1. Figure 11 Building Height Plan being amended as attached.
2. Clause 6.4.1.1 being modified with the height description of Marine Services building changed from three stories to 13.6m.
3. The following words being added to Clause 6.4.1.7:

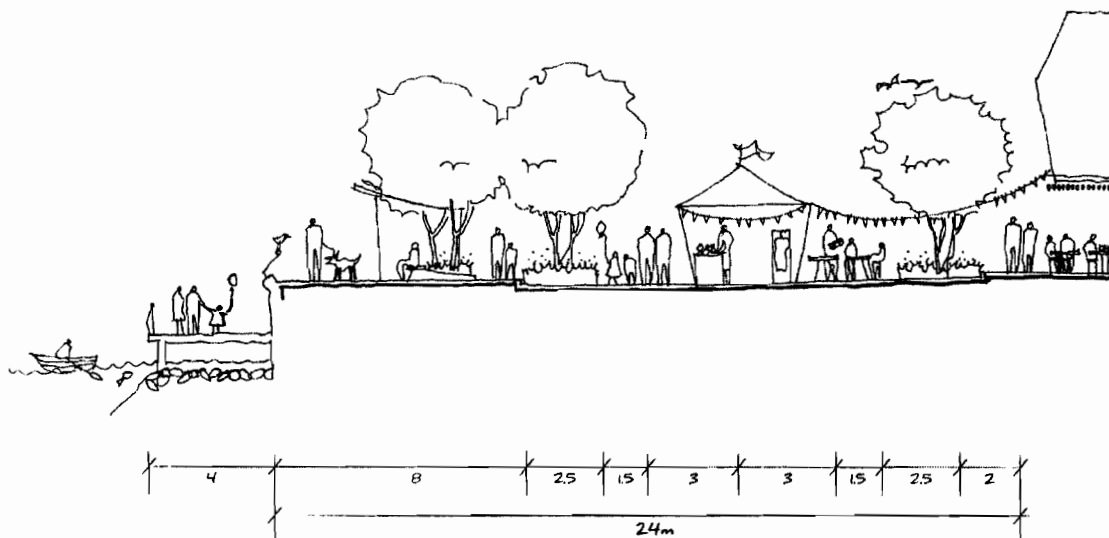
18. Adding to Clause 6.4.1.1 cross sections of Chieftain Esplanade as a multi-use street open to vehicle traffic and as a market/events space closed to vehicle traffic, as shown below:

Chieftain Esplanade – as a multi-use street open to vehicle traffic

Chieftain Esplanade – as a market/events space closed to vehicle traffic

Figure No. 10

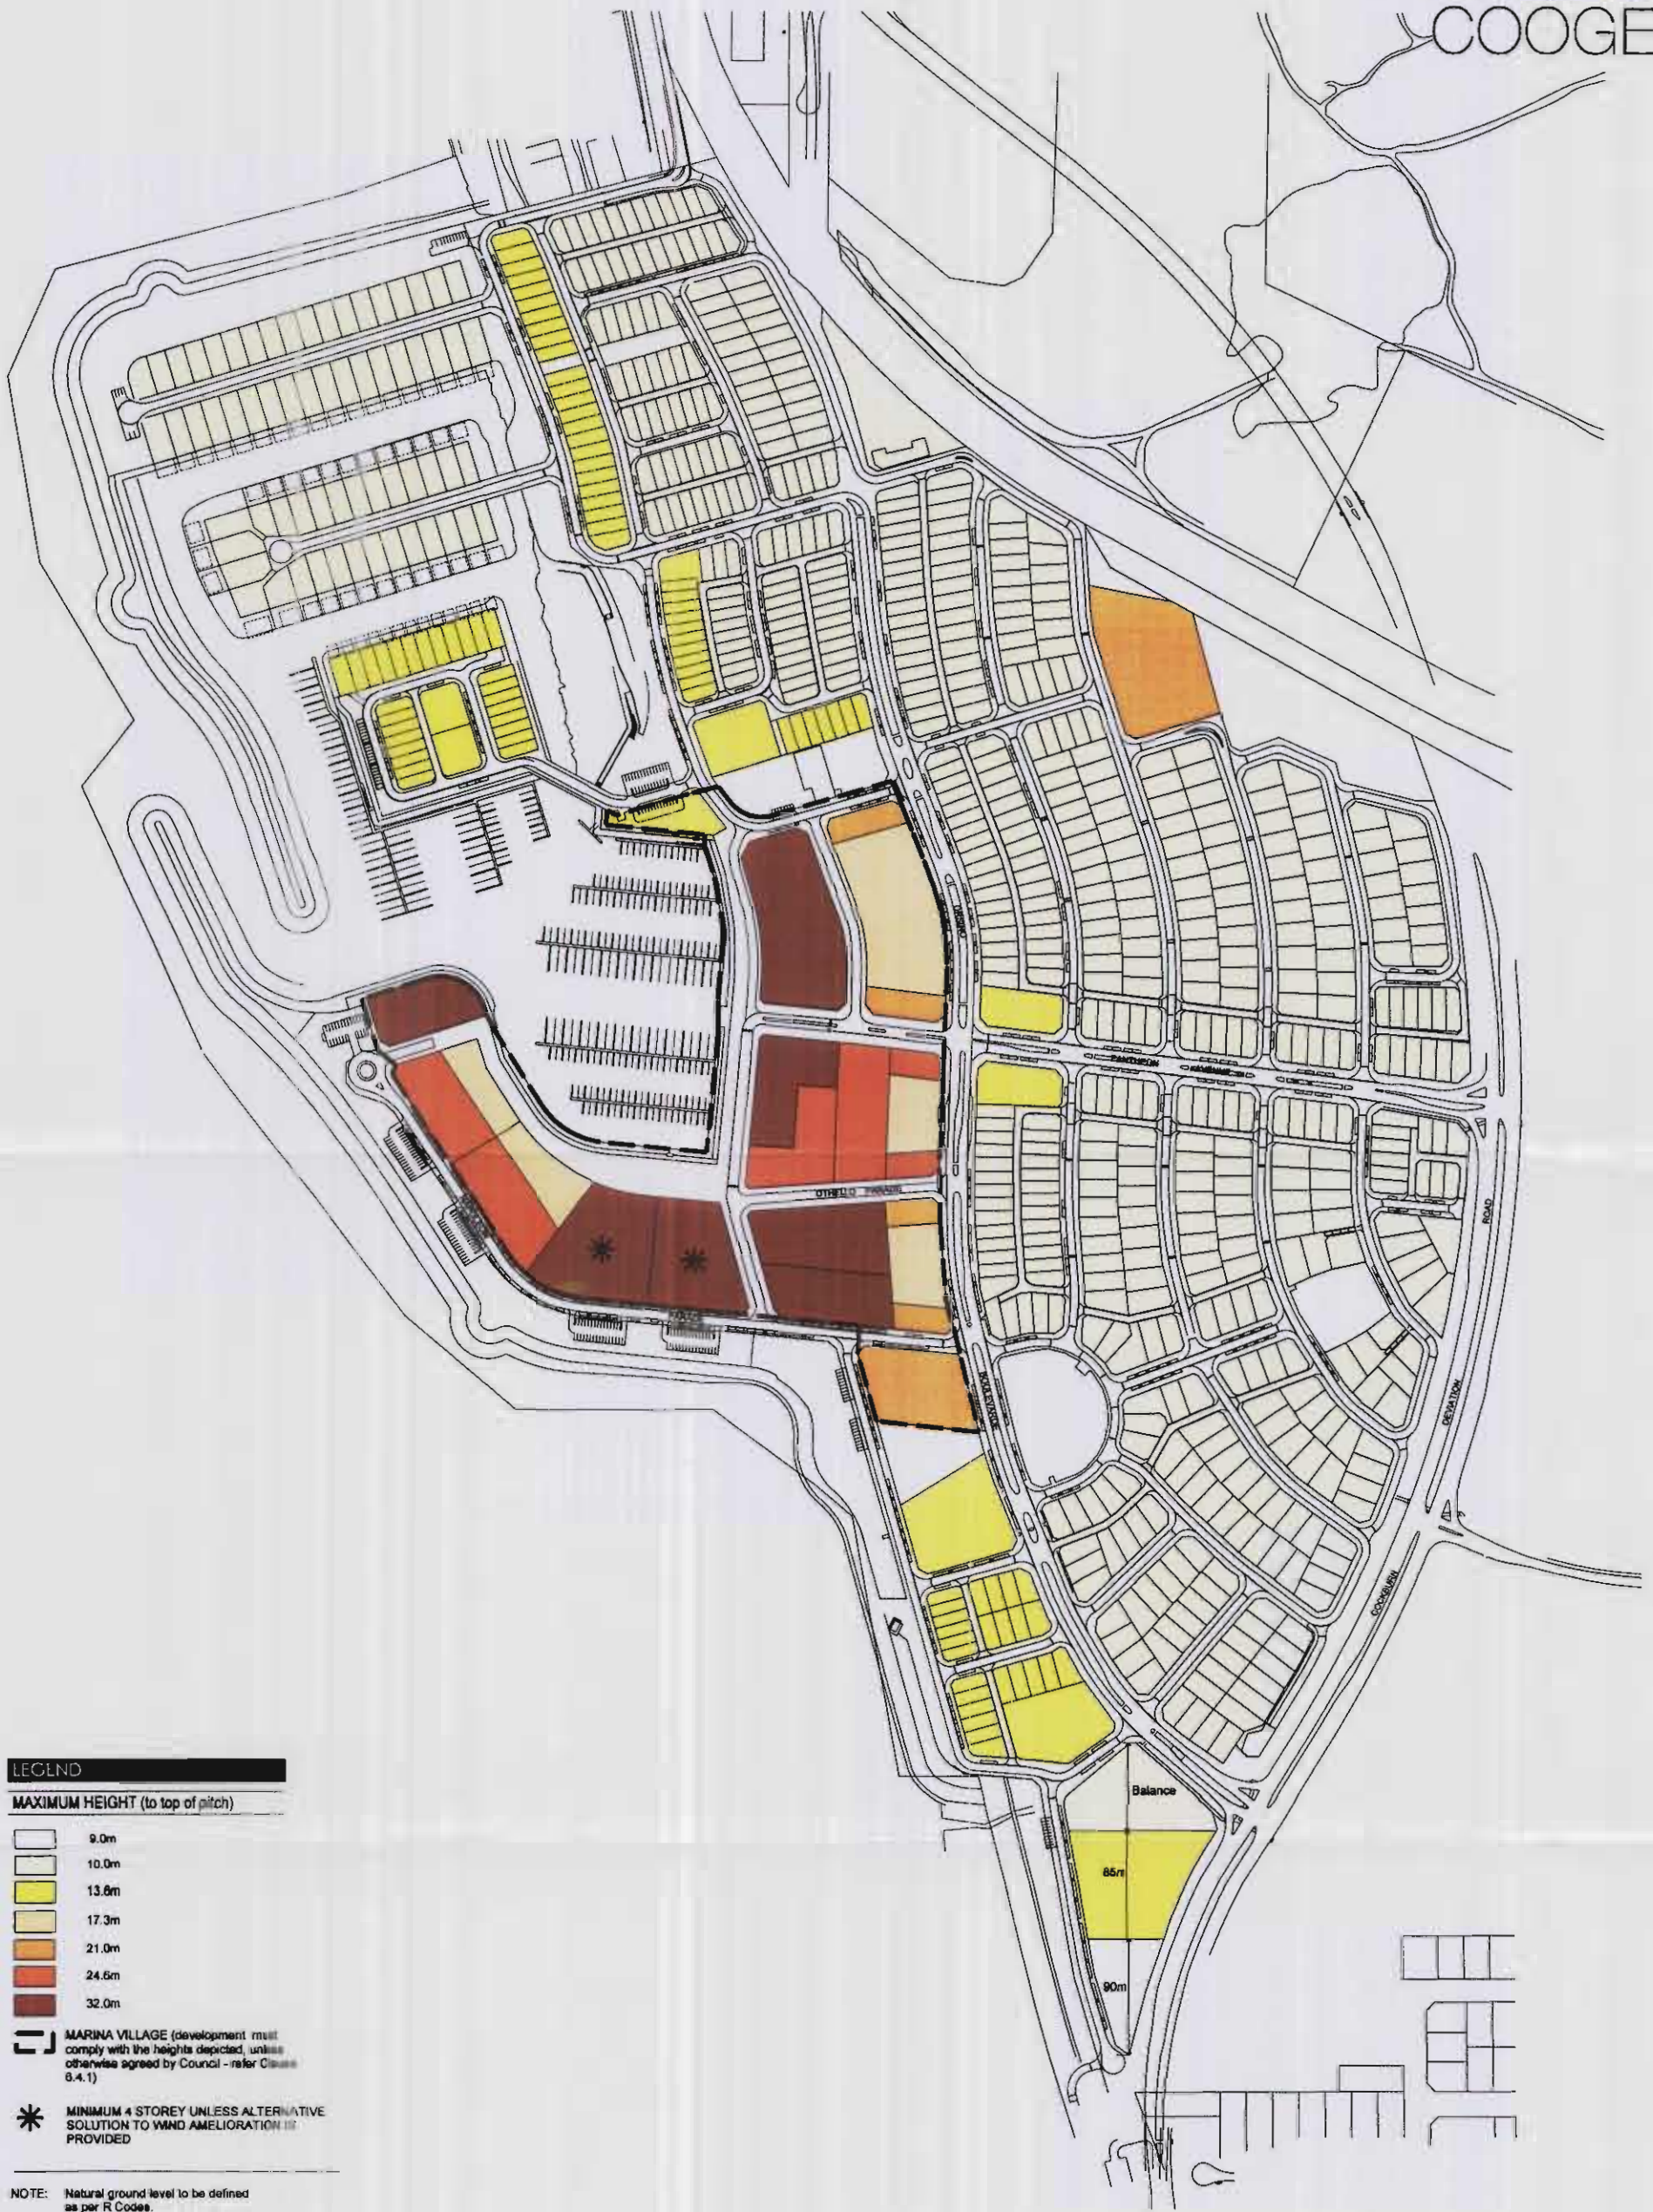
36. Figure 10 being modified (as attached) to add a designation 'Residential landuses to ground floor permitted subject to robust building design and on the basis that the ultimate intention is to encourage as much non-residential frontage as possible at ground floor level along the marina frontage.' This designation is to extend along the marina frontage from Pantheon Avenue northward to the next road intersection near the southern boundary of the marina services building and from the waterfront park (from the boundary of the 'non-residential landuse to ground floor' designation) westward through to, and including, the landmark/icon building on the westernmost point of the southern peninsula.
